In the matter of the Proposed Porirua District Plan

**Statement of evidence of Graeme Robert McIndoe
on behalf of Porirua City Council**

Supplementary Urban Design Evidence

Figure 2: Area for height uplift in the MUZ east of Mungavin Interchange

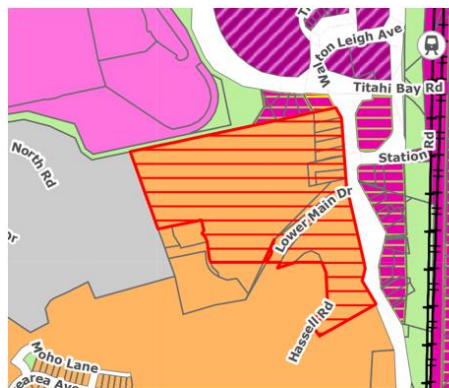
- 16 Considering the height of the area zoned as MUZ and located to the east of Mungavin Interchange by Ranui centre, while I do not support Kainga Ora’s proposal to change the zoning from MUZ to HRZ, I consider that the maximum height here might be increased to 36m as proposed by Kāinga Ora⁴. This is for the following reasons:

- 20 Figure 2 describes the recommended areas for adjusting maximum height with reference to the Kāinga Ora Plan. The extent of the area at Ranui proposed by Kāinga Ora does not relate precisely to lot and proposed MUZ zone boundaries so the proposed boundaries for height uplift here have been adjusted accordingly.

Area for height uplift west off Kenepuru Drive as identified by Kāinga Ora on Attachment F to Mr Rae’s evidence, Sheet 2 of 13

Recommended area for height uplift at Ranui, immediately to the east of the Mungavin Interchange. This is a maximum height uplift for the part of the MUZ here identified by the yellow dashed line.

Figure 1 Area for height uplift in the identified area west of Kenepuru Drive

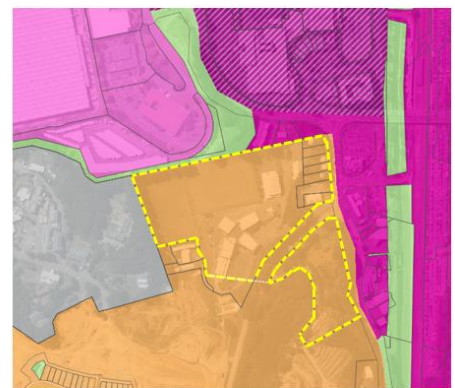
- 14 I have viewed the contours in this area of HRZ just south of the MCZ at the corner of Kenepuru Drive and Titahi Bay Road³ and consider it is suitable to accommodate buildings to an increased maximum height of 36m.

14.1 The height uplift area is set back from steep south facing slopes, so additional shading effects will be apparent, but in my opinion not excessive.

15 Figure 1 describes the recommended areas for adjusting maximum height with reference to the Kāinga Ora Plan.

Area for height uplift west off Kenepuru Drive as identified by Kāinga Ora on Attachment F to Mr Rae’s evidence, Sheet 2 of 13

Recommended area for height uplift at Ranui, immediately to the east of the Mungavin Interchange
